VEC spec for 50GAUI-1 C2M and 100GAUI-2 C2M

P802.3cd Draft 2.2 comment 30

What the spec allows

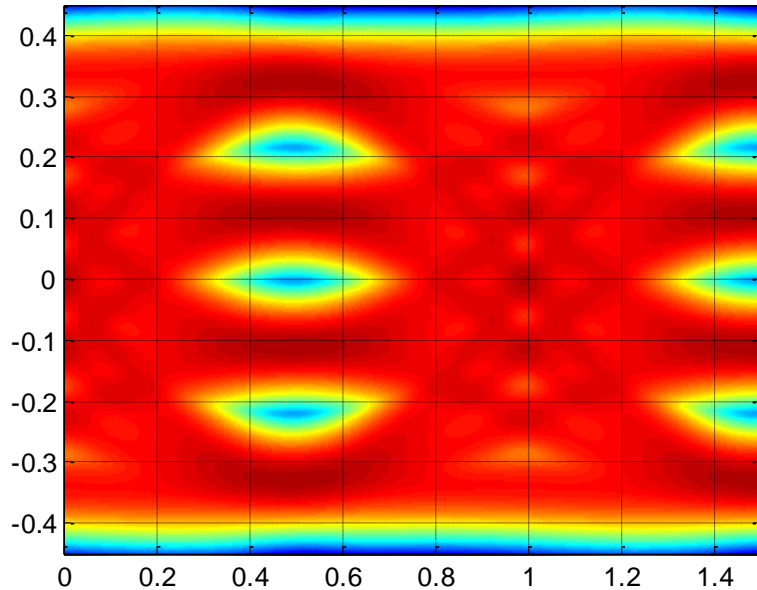
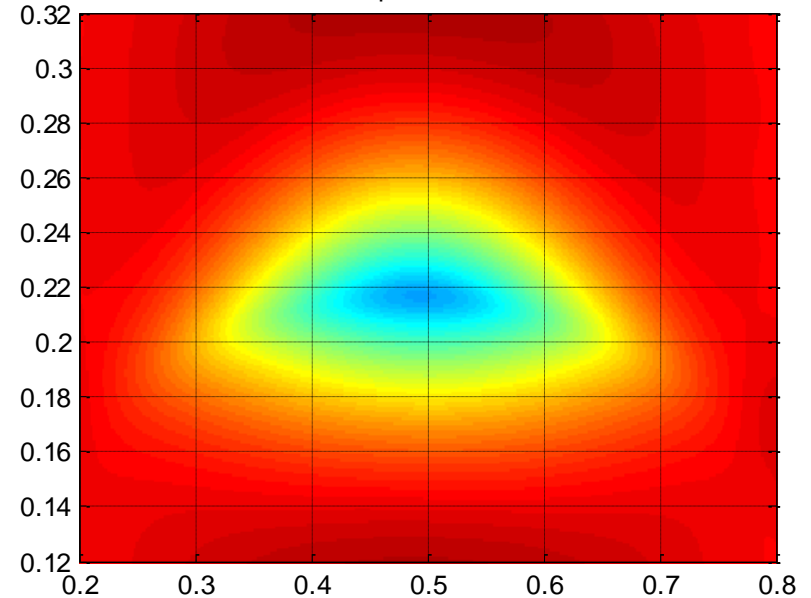
- This output from a low loss host is allowed by the spec. The signal is more than 2.5x bigger (0.83 V pk-pk vs. 0.31 V after CTLE) but the eye height (usable opening) is still only 35 mV for eye width at minimum. This signal's **VEC is 15.8 dB**.
 - It was hoped that the eye width spec would enforce a better eye height. But it doesn't do so significantly – a host could have less UBJ and more noise than this one, taking the eye height closer to the minimum 32 mV

- Receiving a small inner eye in a big signal stresses tuning and linearity "dynamic range" issues that are beyond the module stressed input test
- Very blurred eye, i.e. ratio $V_{pkpk} / \text{eye height}$ is too large
 - Next slide 7 shows the low loss module stressed input test; the high loss case is on slide 4
 - A module stressed input signal would not be like slide 5 which has much worse noise or ILD than the stressed eye generator

- The module stressed input signals (slides 4, 7) have VEC around **8 dB**
- The bigger, blurry, but still near minimum height, eye (slide 5) has a VEC about **16 dB**
- A low loss host might have a worse VEC than a high loss host, but not 8 dB worse
- **Limit the host output VEC to 12 dB**
 - There is no need to do the same for the module output because the signal swing is limited before the host loss and the minimum eye height is enforced both before and after it
 - Use VEC rather than V_{pkpk} / eye height because we know how to specify and measure it
 - See P802.3bs D2.0 120E.4.2.1 Vertical eye closure
 - This was removed for D2.1 because it was not needed for the module output as well as the far end eye spec (D2.0 comment 173)
- This change could be made in P802.3cd sponsor ballot

What the spec would allow – 14 dB

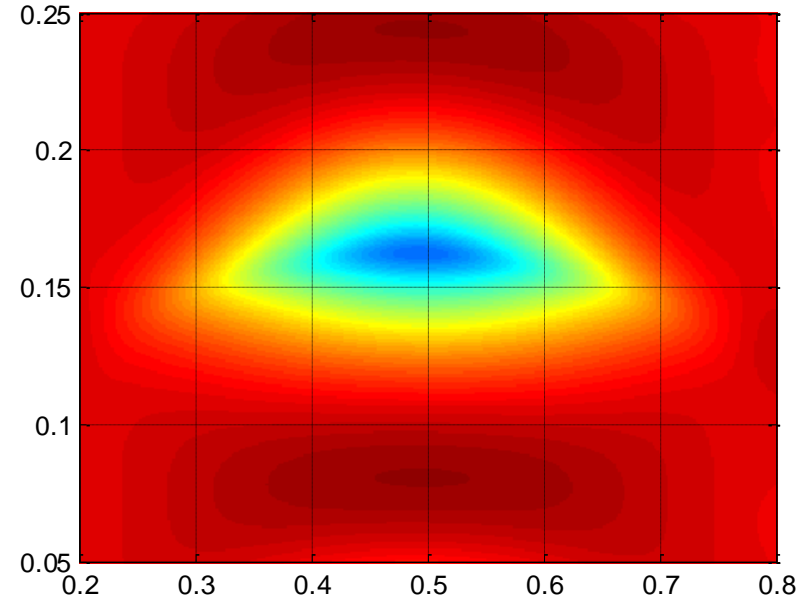
- This signal 0.67 V pk-pk after CTLE
- **VEC is 13.8 dB**
- Eye height is 33 mV

What the spec would allow – 12 dB

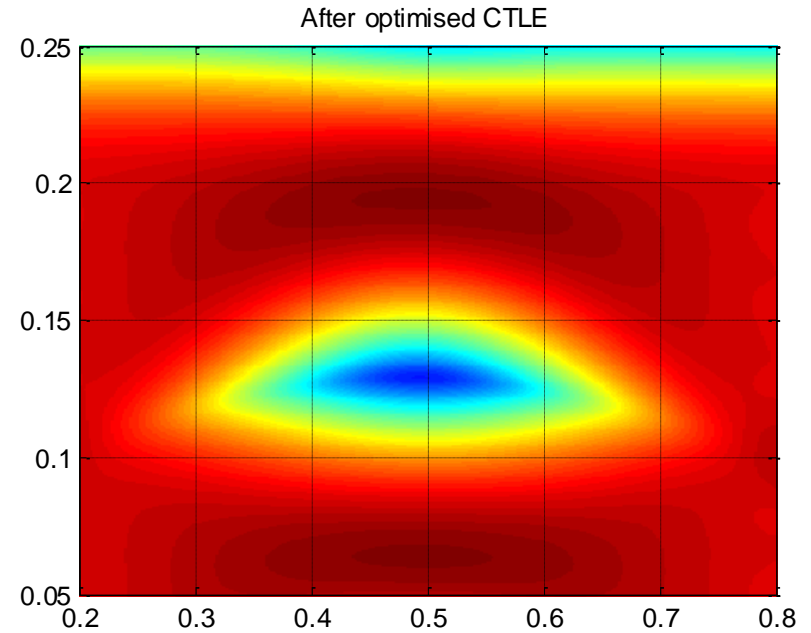
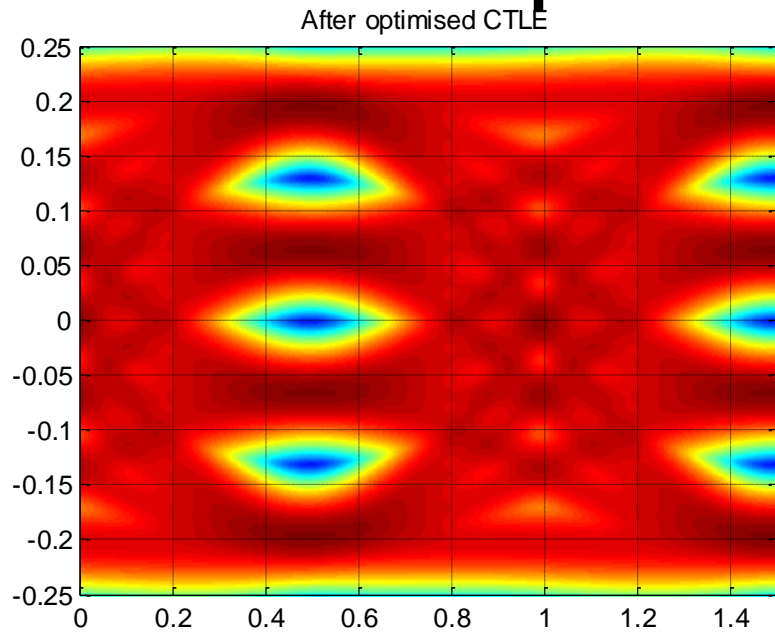
- This signal 0.49 V pk-pk after CTLE
- **VEC is 12.0 dB**
- Eye height is 32.6 mV

Figure showing AV_x used for calculating VEC

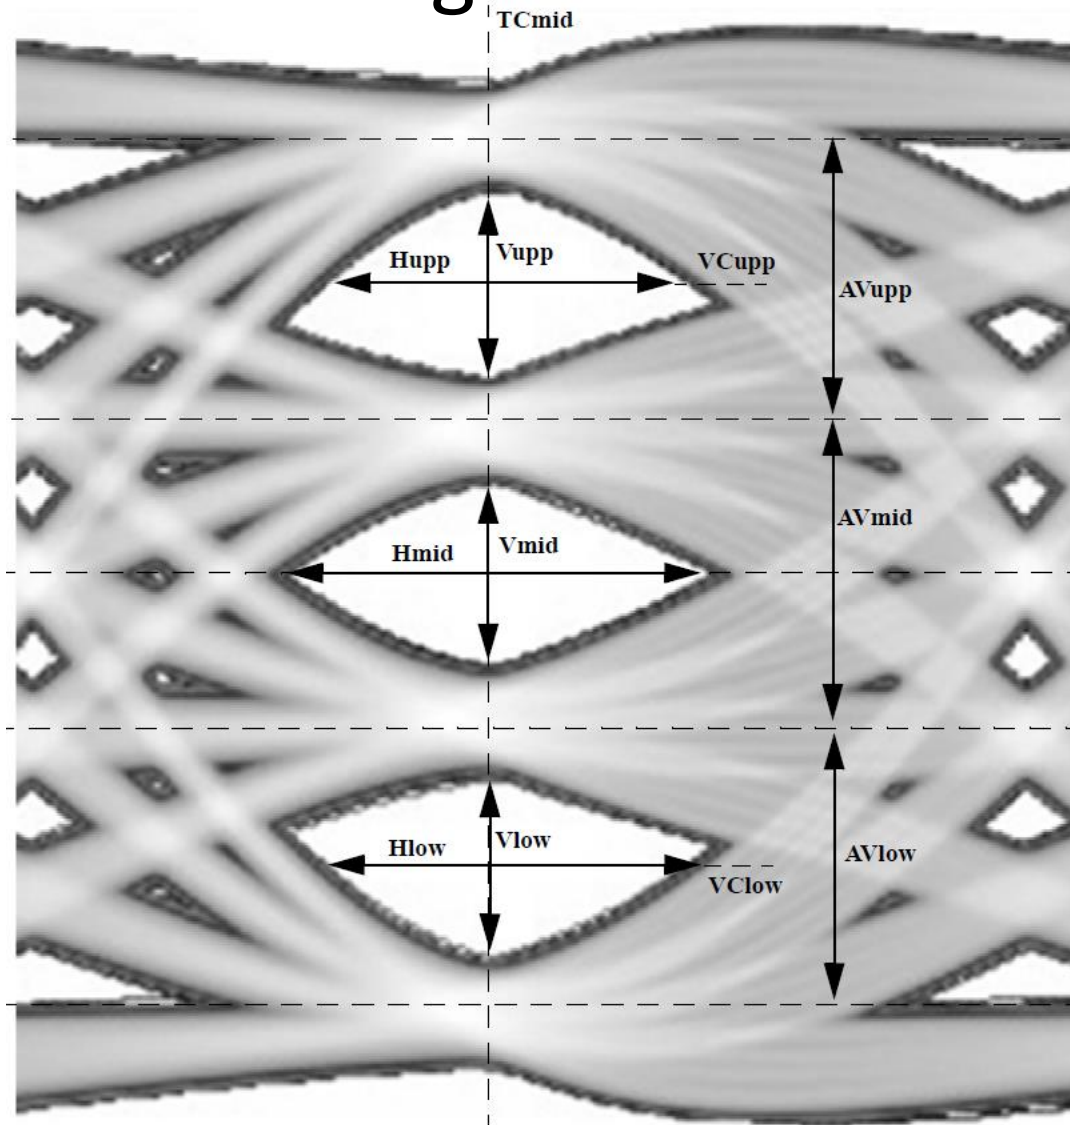
See example equation defining VEC on next slide

- Vertical eye closure is defined for the host output by Equation (135G–1).
- $VEC = 20\log_{10}(\max[Av_{upp}/V_{upp}, Av_{mid}/V_{mid}, Av_{low}/V_{low}])$ (135G–1)
